## 02 Elevations

### Milk Street

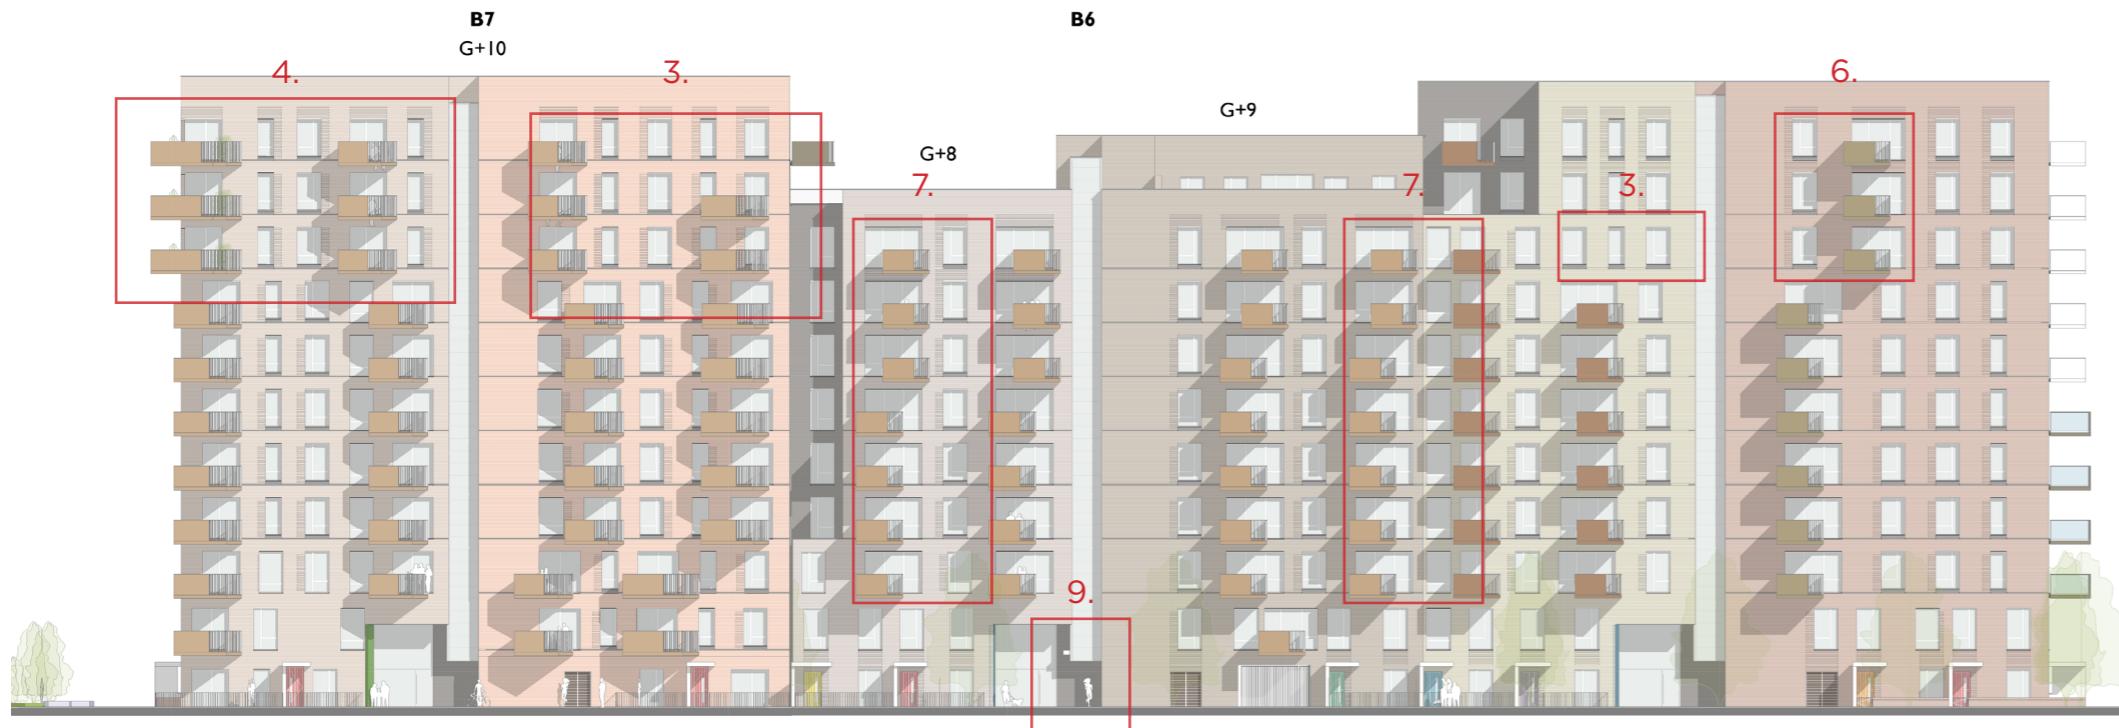
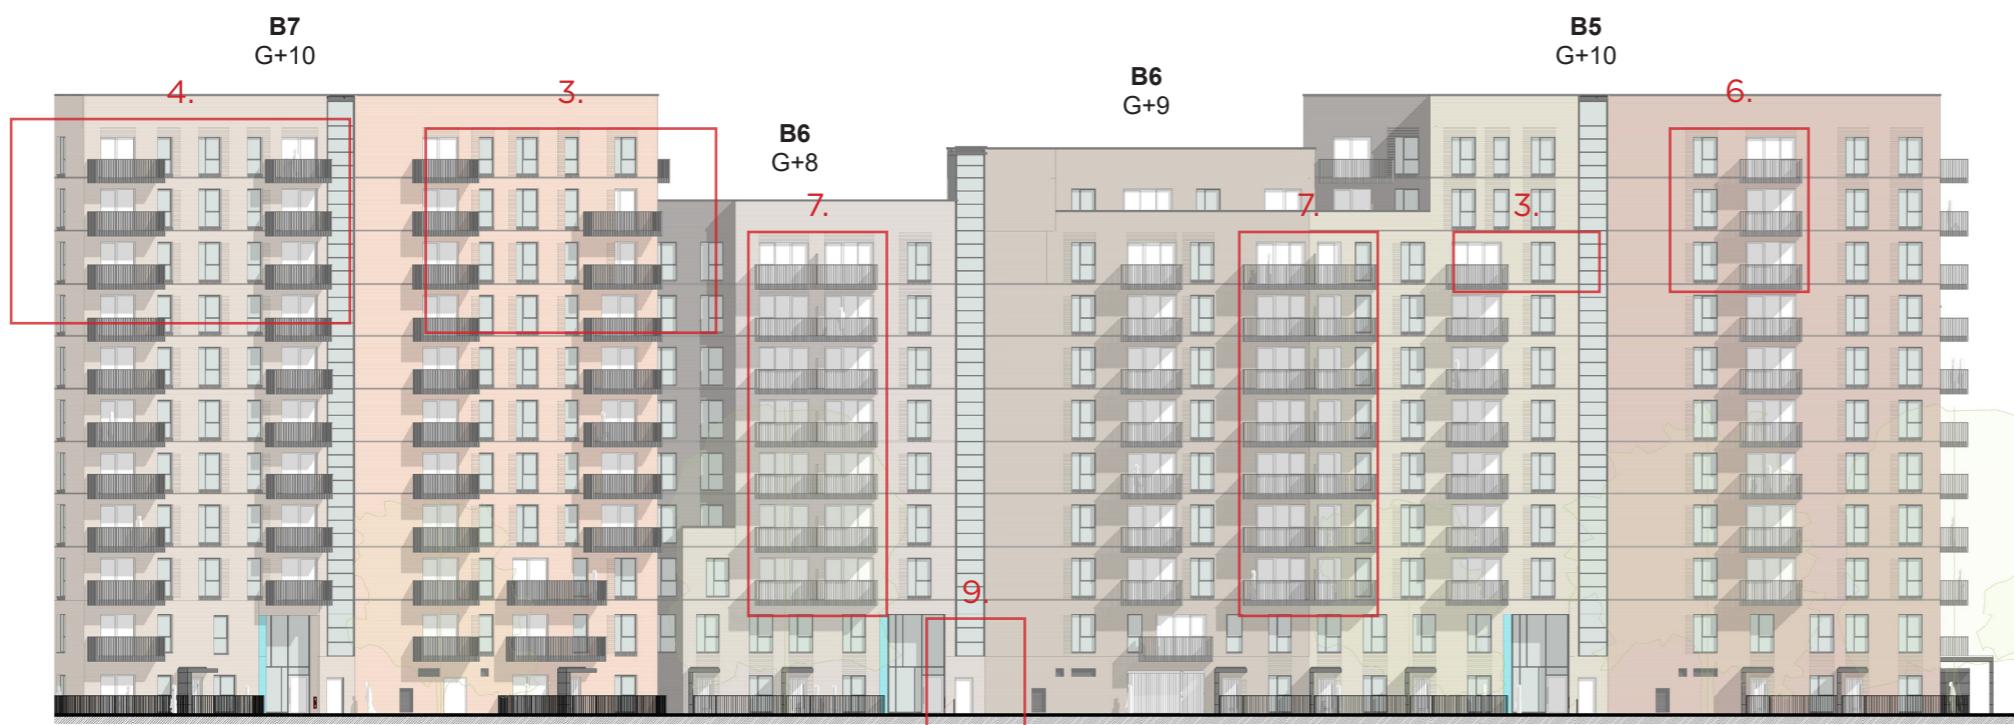
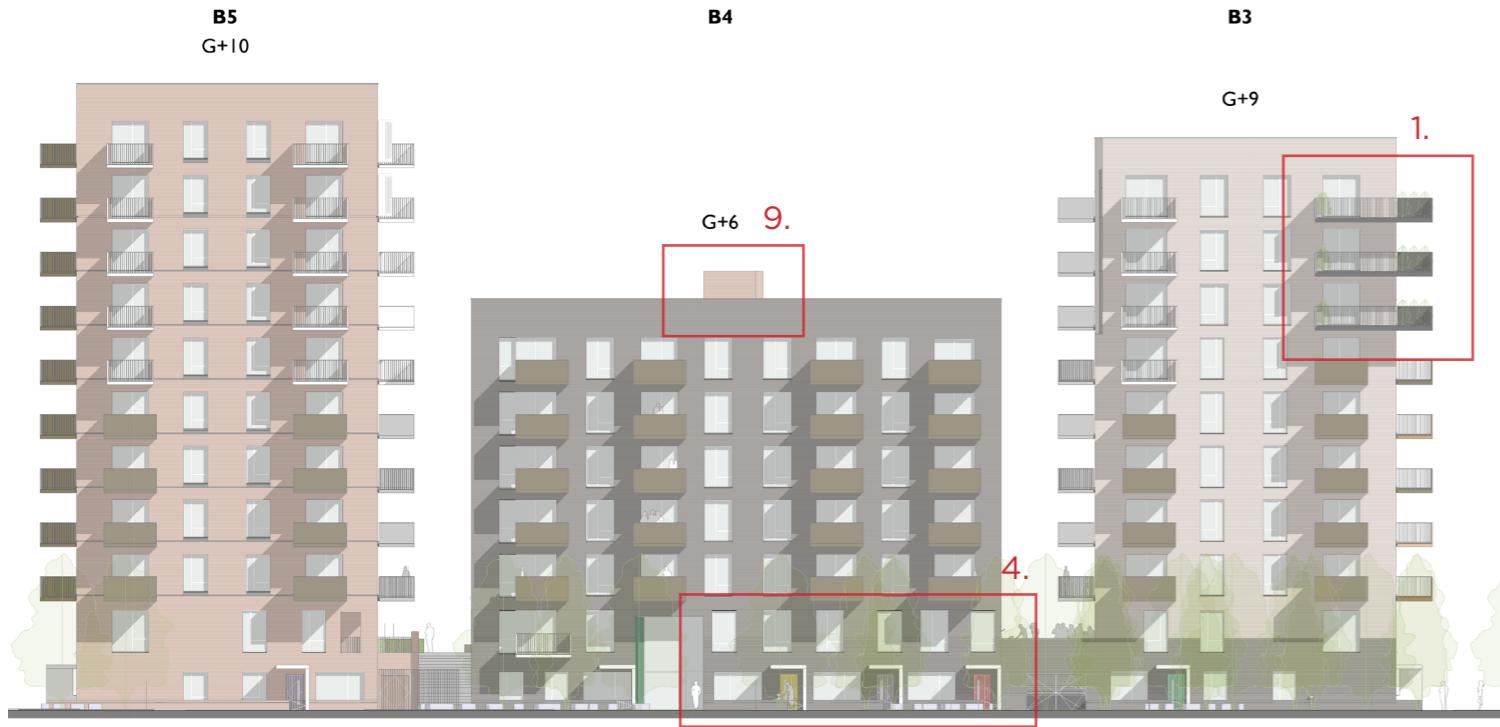
1. Rationalisation of balcony design as per previous phases
2. Windows omitted to suit developed stair/lift core design
3. Rationalisation of apartment stacking to facilitate drainage stacking / co-ordination
4. Window amended to ensure consistency between apartment type layouts
5. Window reduced to avoid internal clashes
6. Rationalisation / standardisation of balcony types
7. Balconies re-sized and linked to ensure compliance to London Plan area standards
8. Window type amended to match adjacent levels
9. Adjustment of architectural articulation

### Sandow Square

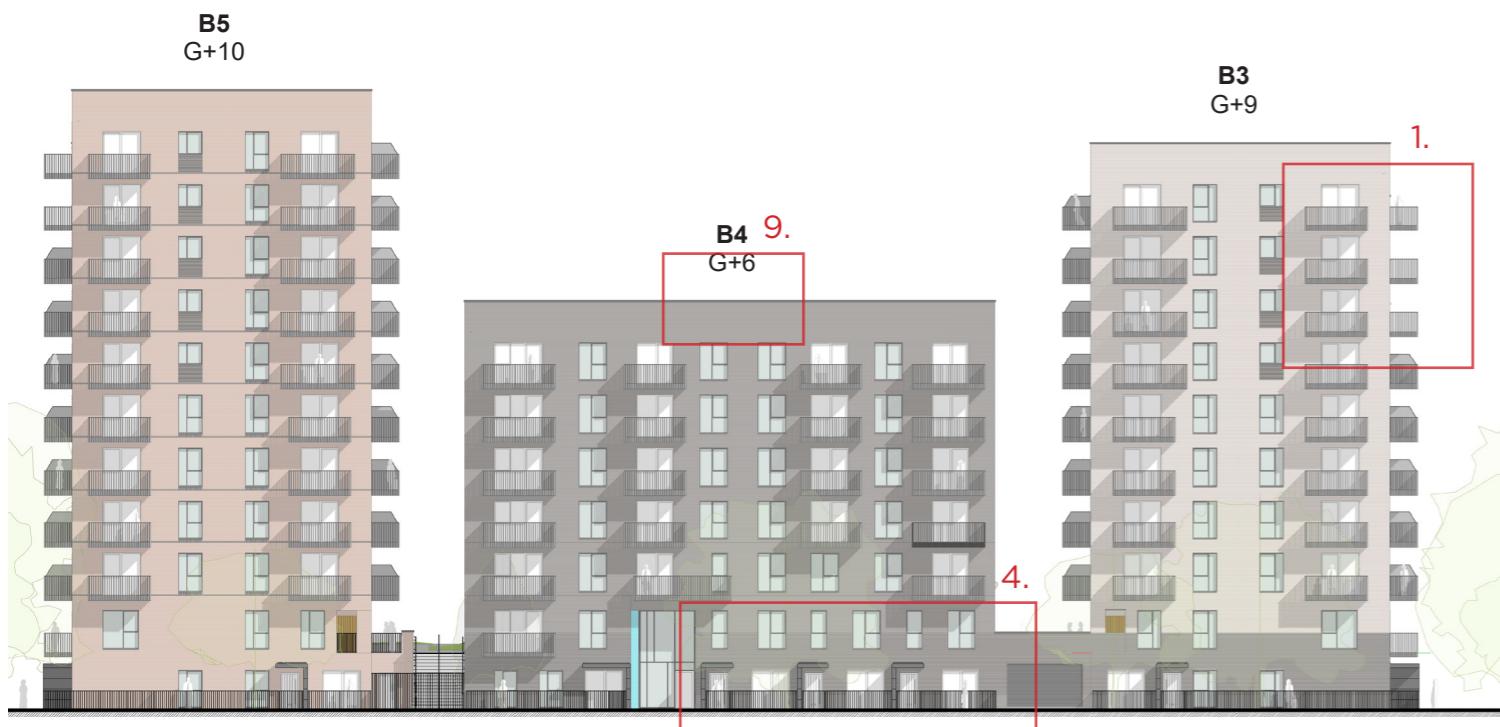
1. Rationalisation of balcony design as per previous phases
2. Windows omitted to suit developed stair/lift core design
3. Rationalisation of apartment stacking to facilitate drainage stacking / co-ordination
4. Window amended to ensure consistency between apartment type layouts
5. Window reduced to avoid internal clashes
6. Rationalisation / standardisation of balcony types
7. Balconies re-sized and linked to ensure compliance to London Plan area standards
8. Window type amended to match adjacent levels
9. Adjustment of architectural articulation
